Work Order ID 62608

Item Name: Basket Hoop

DESIGN #	DRAWN BY CP	DART AEROSPACE LTD HAWKESBURY, ONTARIO, CANADA	
CHECKED #	APPROVED #	DRAWING NO. D3166	REV. A SHEET 1 OF 1
DATE 02.07.10		TITLE BASKET HOOP	SCALE NTS
A	02.07.10	NEW ISSUE	
A1	04.04.08	38+/-1 WAS 36.0

DRAWING NO. D3166	TITLE BASKET HOOP	REV A1	DART AEROSPACE LTD ENGINEERING ORDER		D.E.O. NO. D3166-A-2	SHEET NO. 1 OF 1	SCALE NTS
DRAWN AJS	CHECKED	MFG. APPR.	APPROVED		DE APPR.		
DATE 08.12.11	DATE 08.12.15	DATE 08/12/15	DATE 08/12/16		DATE 08.12.16

D3166-1 BASKET HOOP

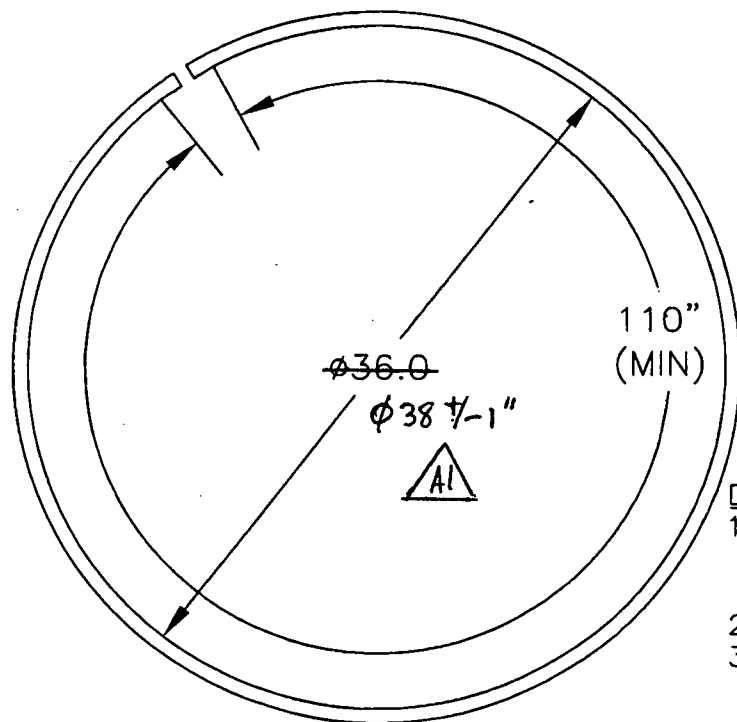
10.6 (REF, NEED 8.0 MIN)

1) MODIFY MATERIAL NOTE FOR D3166-1 AS SHOWN:

2) MODIFY MATERIAL NOTE FOR D3166-3 AS SHOWN:

1) MATERIAL: AISI 304/316 SS, 3/4 X 3/4 X 0.065 WALL SQUARE TUBING,
60.00" LONG
REF. DART SPEC M304TS0.750W.065

1) MATERIAL: AISI 304/316 SS, 3/4 X 3/4 X 0.065 WALL SQUARE TUBING,
120.00" LONG
REF. DART SPEC M304TS0.750W.065
